Access Compliance Report

Public Rights-of-Way

(Curb Ramps)

Intersection ID: 9651	Main Street: CRESTVIEW_DR	Cross Street: FRENCH_ST	Location: SW
ADA ID: 86A0343FAB84	Ramp Type: Directional1	Initial Pass/Fail: Pass	Overall Compliance: No
			Severity Score: 2.75

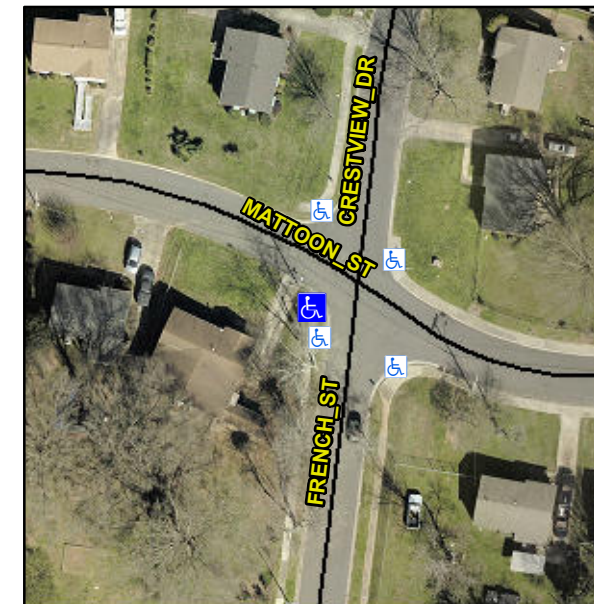
**Not Found, R304.2.2-Perp, R304.3.2-
Para, R304.5.3, R304.5.2, R305.1.4,
R305.2**

**Remove & Replace Entire Ramp.
Remove & Replace Gutter.**
